Change Order

PROJECT (Name and address):	CHANGE ORDER NUMBER: 005	OWNER: ⊠
North Hardin High School Renovation	DATE: April 21, 2016	ARCHITECT: ⊠
North Hardin High School 801 S. Logsdon Parkway		CONTRACTOR: ⊠
Radcliff, Kentucky 40160		4000000
TO CONTRACTOR (Name and address):	ARCHITECT'S PROJECT NUMBER: 1291	FIELD: []
Morel Construction Co., Inc.	CONTRACT DATE: February 09, 2015	KENTUCKY DEPARTMENT OF
627 West Main Street Louisville, Kentucky 40202	CONTRACT FOR: General Construction	EDUCATION:
Louisvine, Kentucky 40202		
	amount attributable to previously executed C	
Changes to the contract shown on the attack totalling an add of \$35,162.00 to the contract.	ned "Itemization of Change Order #5" and accet.	companying supporting documentation,
The original Contract Sum was The net change by previously authorized C The Contract Sum prior to this Change Ord The Contract Sum will be increased by this The new Contract Sum including this Chan	er was. Change Order in the amount of	\$ 13,380,000.00 \$ 97,745.00 \$ 13,477,715.00 \$ 35,162.00 13,512,877.00

N. Hardin High School – Phase 7 SCB Project No. 1291

Itemization of Change Order #5

Drawings: E2.5B, M1.6C, P1.5C and P2.3F

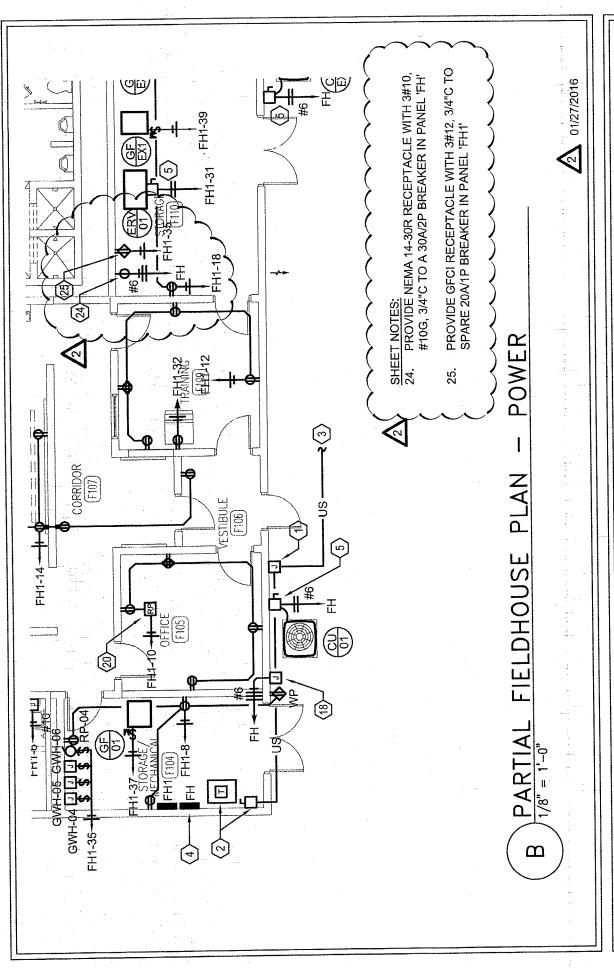
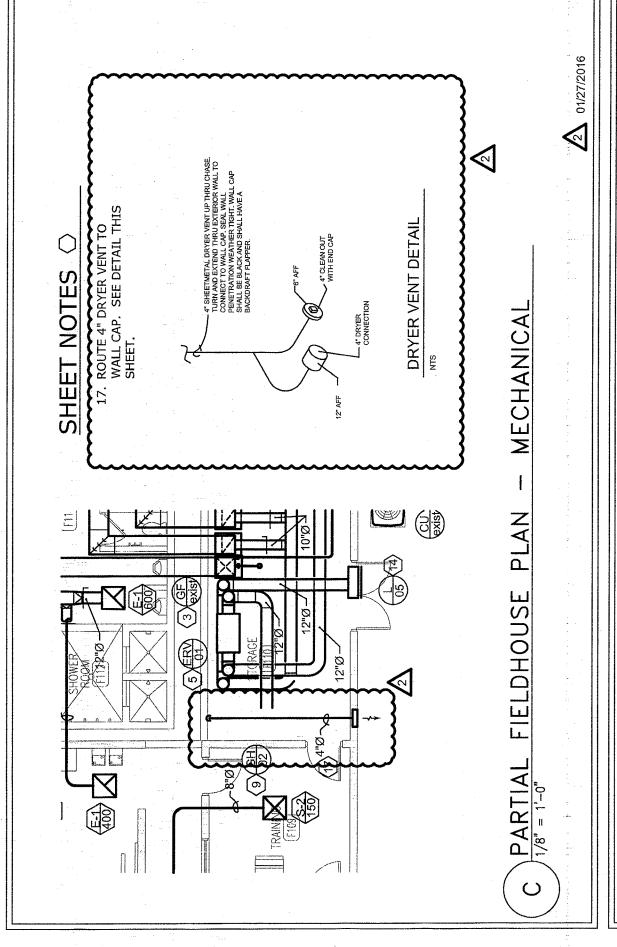
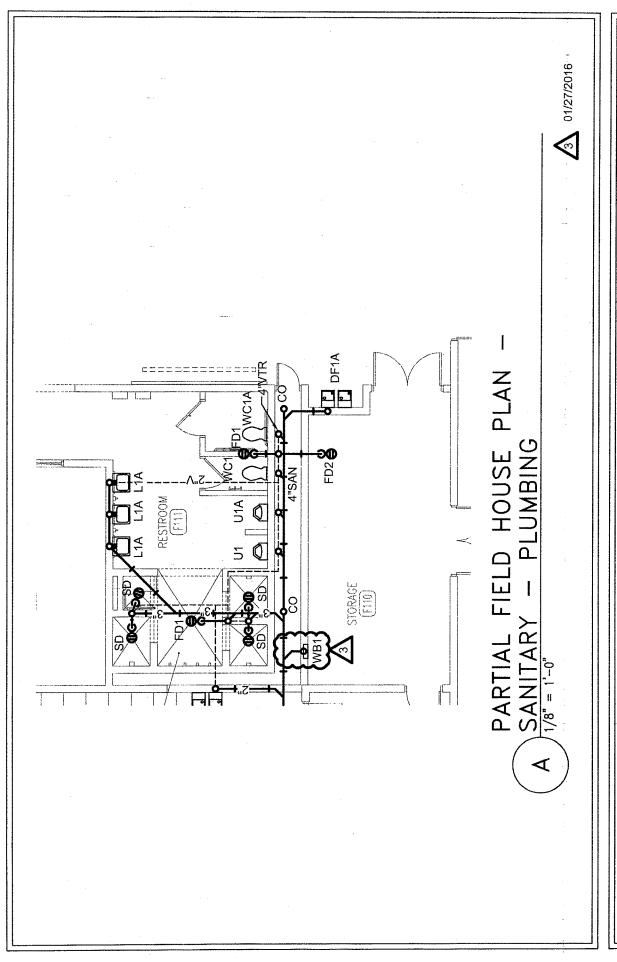
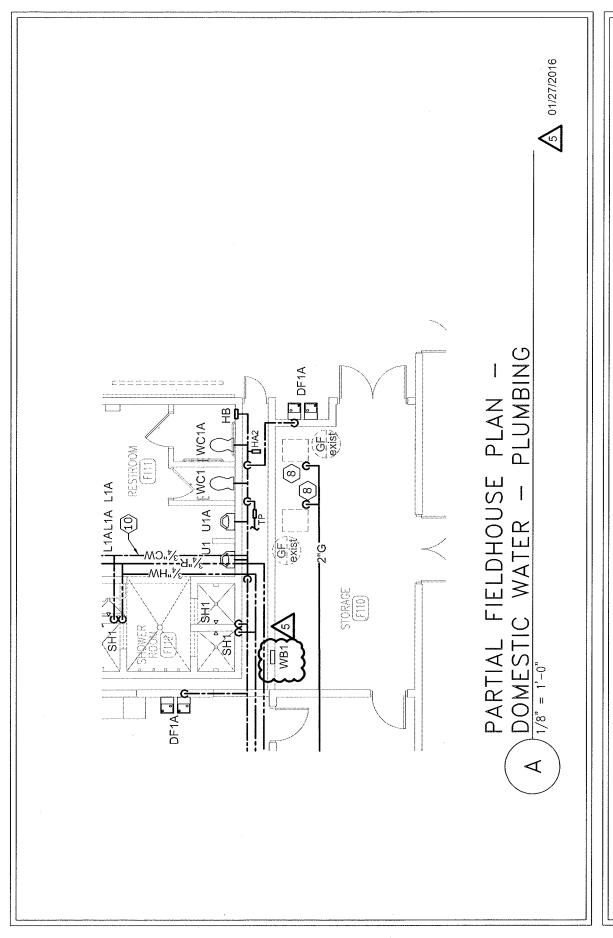
Contractor shall submit a cost proposal to provide washer/dryer hook-ups at the fieldhouse per the attached drawings.
